**RE: Royal Far West Redevelopment Manly
Section 4.55 – Transport Impact Statement**

COMPLIANCE REVIEW

ROYAL FAR WEST CAMPUS REDEVELOPMENT, MANLY
BASEMENT LEVEL 2

ARCHITECTURAL BASE IN BLUE
DRAWING S4.55-111
ISSUE A
BY MURCUTT CANDALEPAS
DATED 11.12.2023

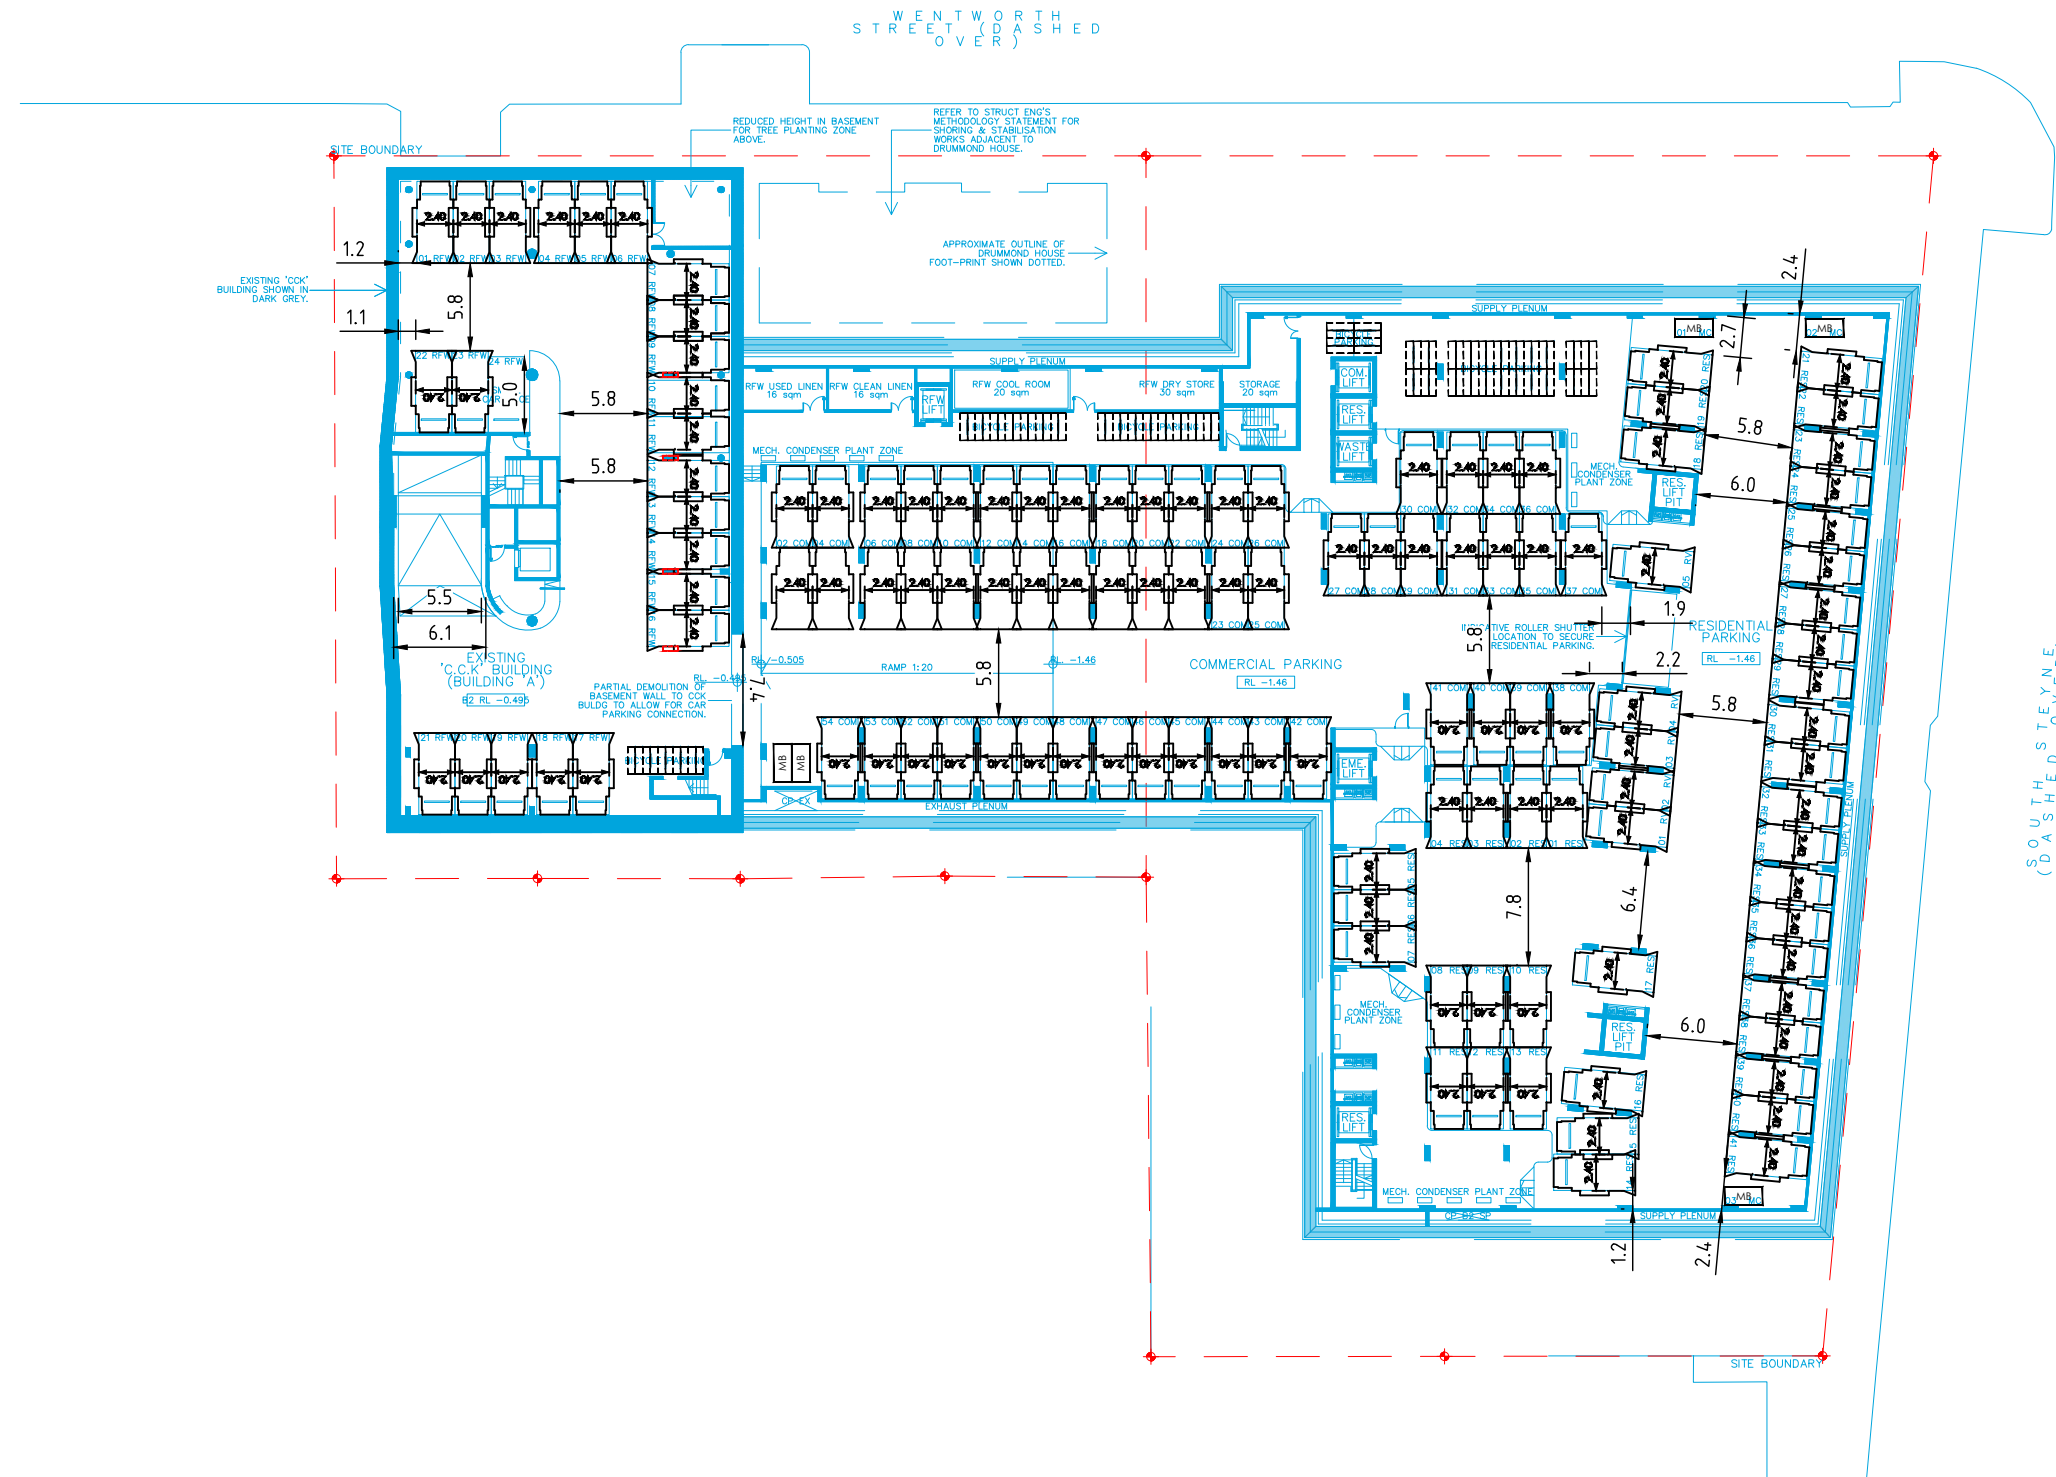
DIMENSIONS ABOVE SHOULD BE REDUCED BY 0.2m TO ACCOMMODATE SMALL CARS (5m LONG SMALL CAR BAYS).

ACCESS CONSULTANT TO CONFIRM
SUITABILITY OF DISABLED PARKING
SPACES.

ARCHITECTURAL BASE IN BLUE
DRAWING S4.55-110
ISSUE A
BY MURCUTT CANDALEPAS
DATED 11.12.2023

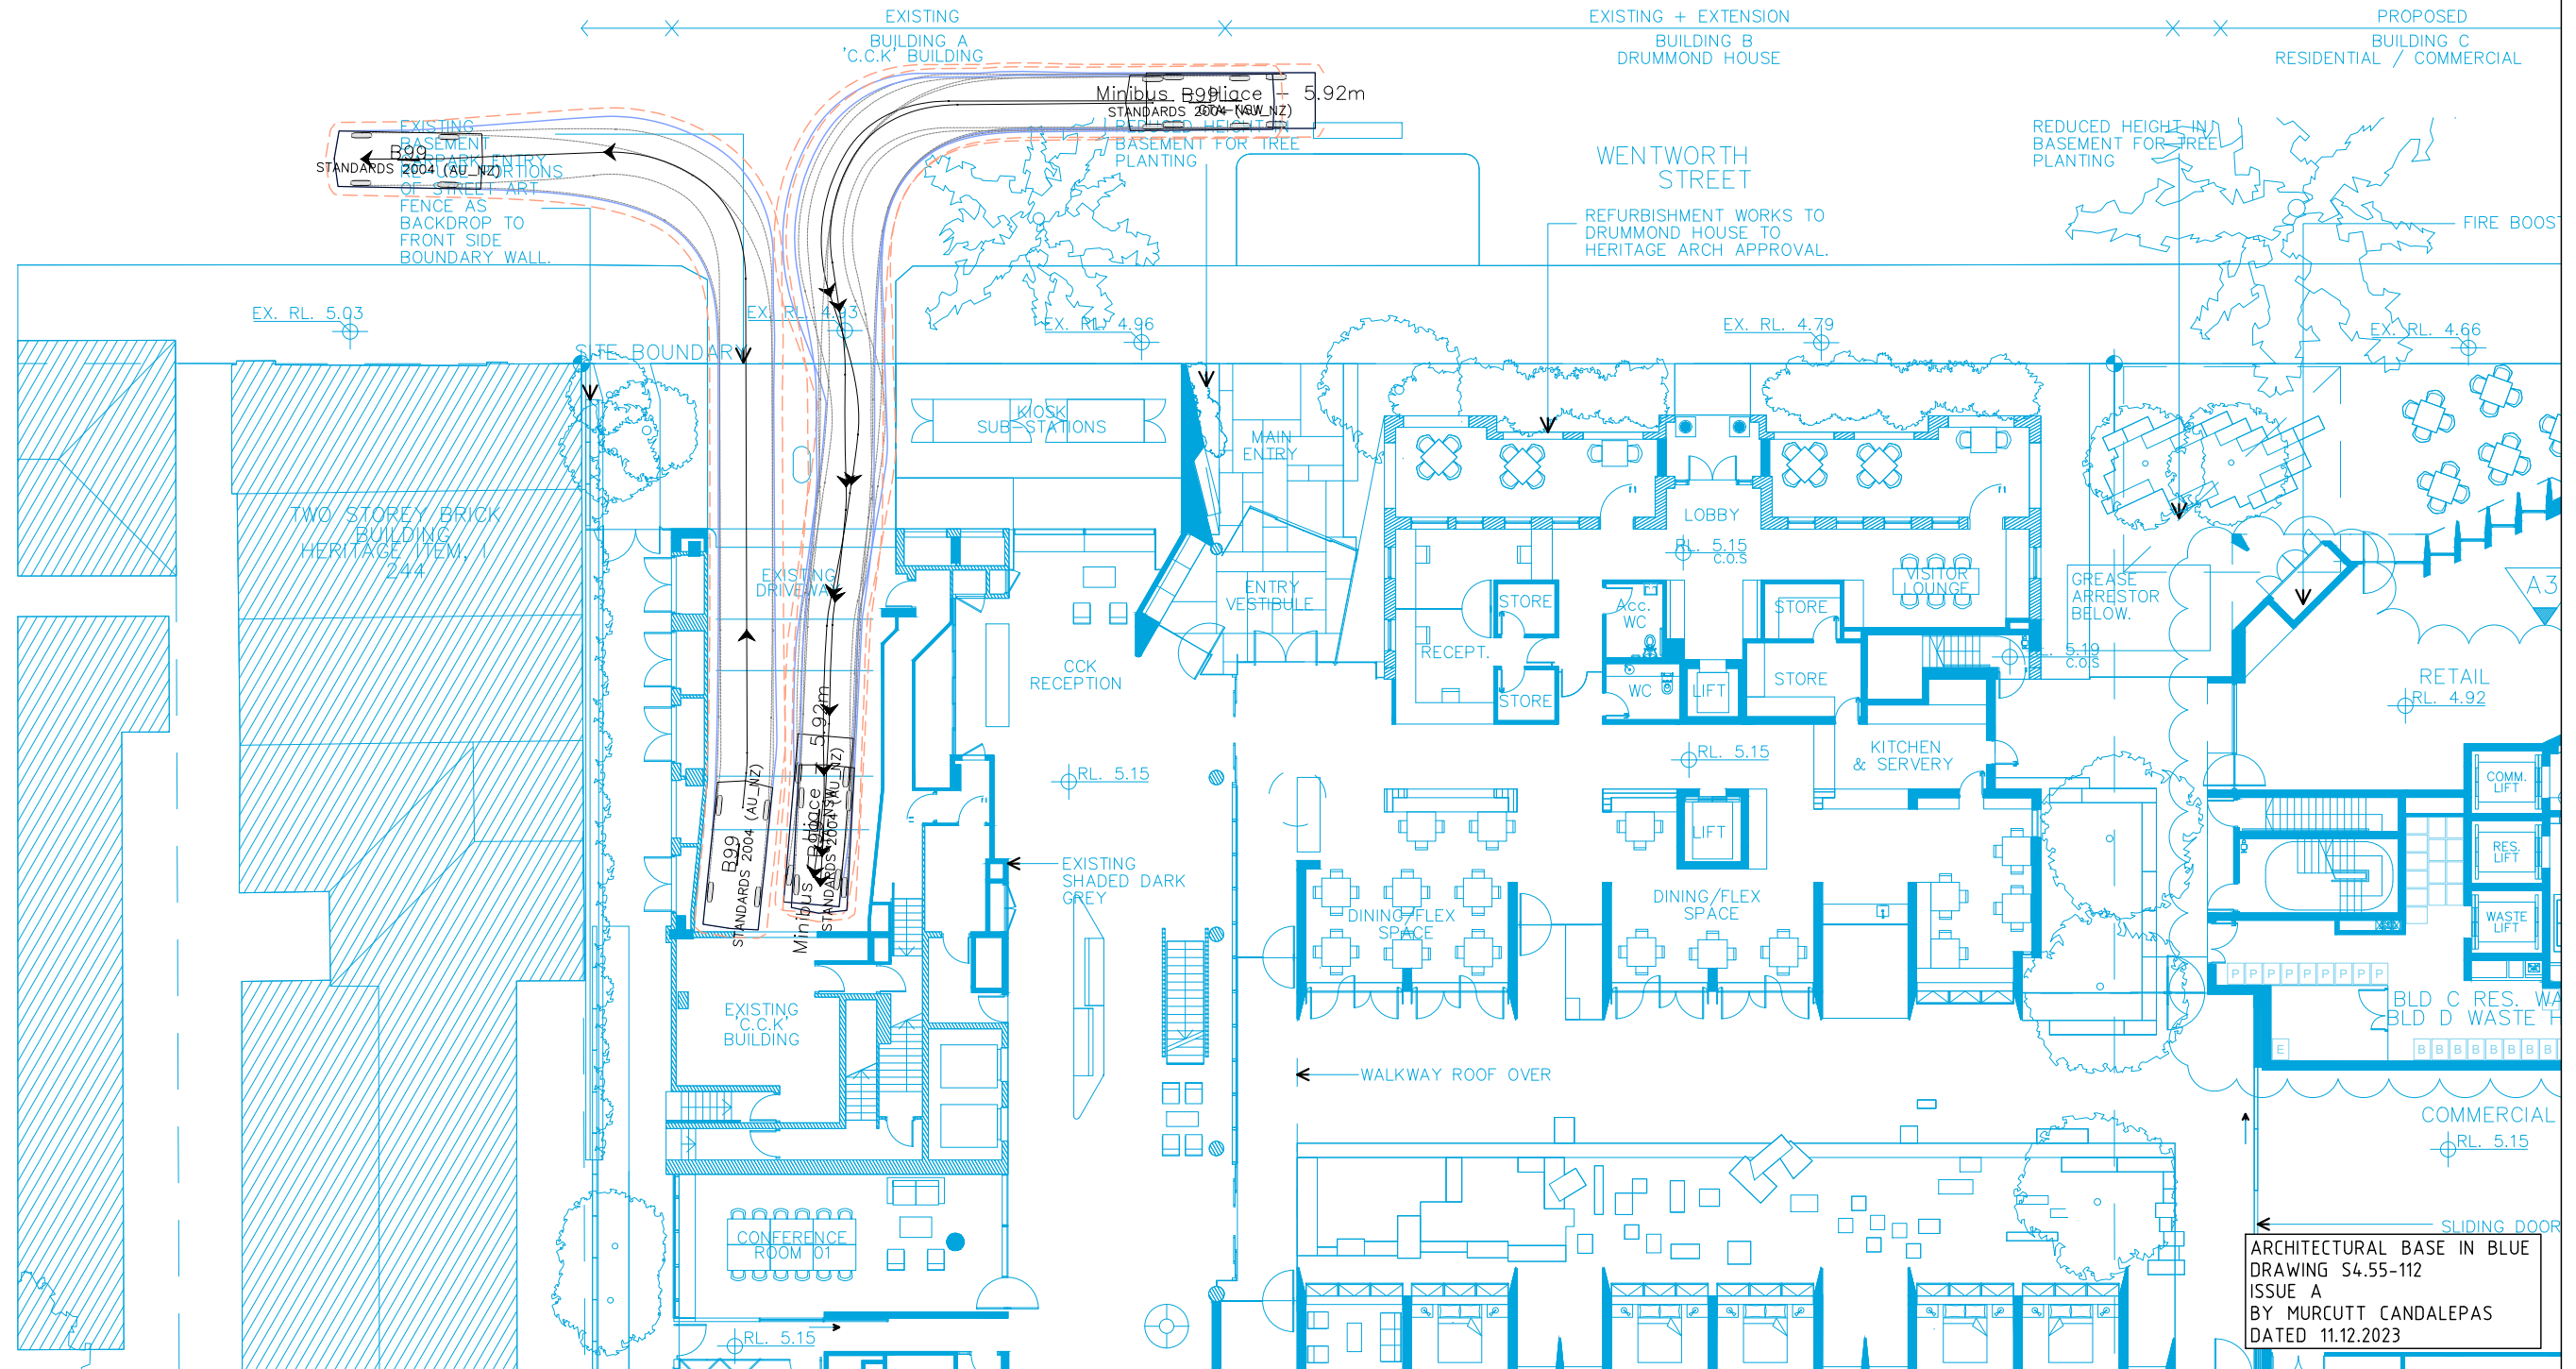
NOTE: CYCLISTS WILL LIKELY HAVE TO USE LIFTS TO ACCESS BASEMENT PARKING FACILITIES, AS GRADES ON RAMPS WOULD BE CONSIDERED TOO STEEP FOR MOST USERS.
